To:
Cc:
Bcc:
Subject: Fw: Planning Application No. A/YL-KTS/852 - Transport Department (TD)'s comments
From: Ivy Ching Yan CHEUNG/PLAND/HKSARG - Thursday 16/07/2020 15:54

Planning Application No. A/YL-KTS/852 - Respond to TD's comments as below:

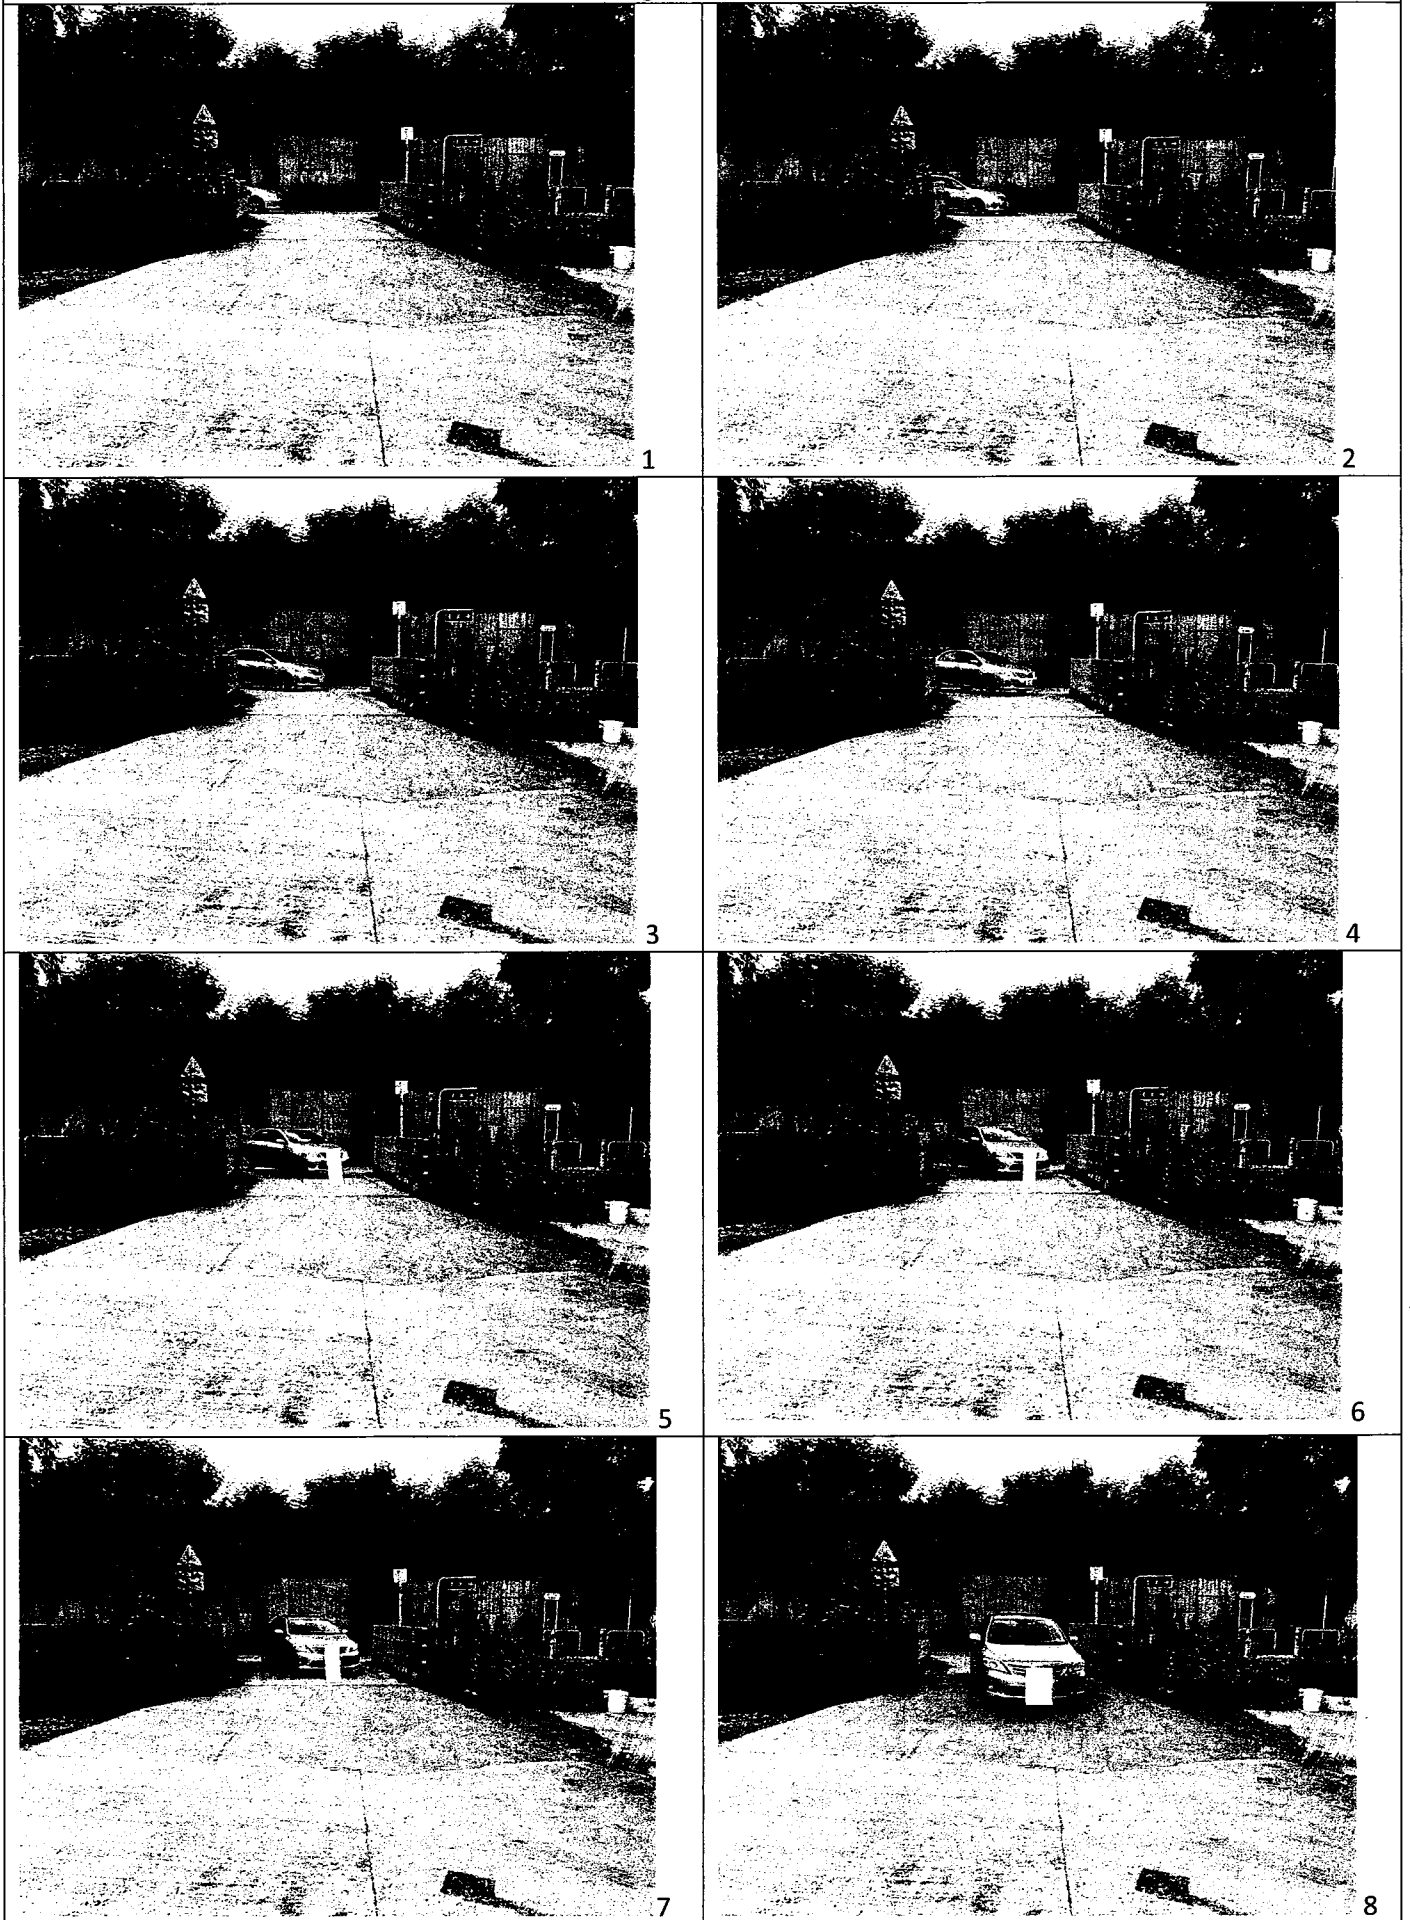
- f. The applicant should demonstrate the smooth manoeuvring of vehicle to / from Kam Po Road and within the site.

Please refer to the attached photos

Run-in / out of Kam Po Road to the development site.

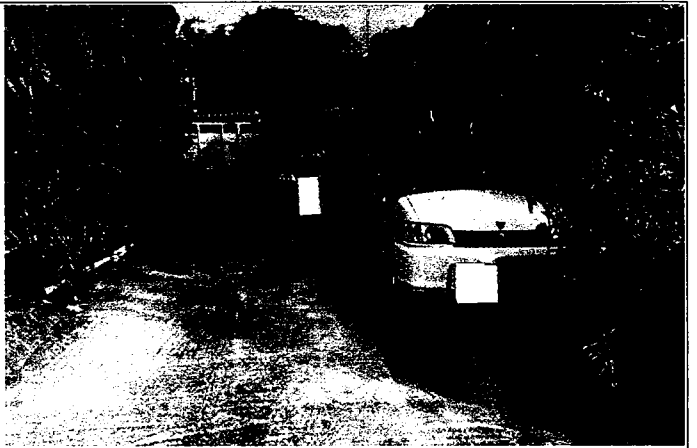
- e. The applicant should clarify if a run-in / out would be constructed at Kam Po Road for the development. In addition, the applicant should clarify if vehicular traffic would use the footpath connecting the nearby footbridge and the footpath at Kam Po Road.

No run-in/ out would be constructed at Kam Po Road for the development as the run-in / out has already constructed by HyD during the construction of Kam Po Road. Please refer to the attached photos for detail.
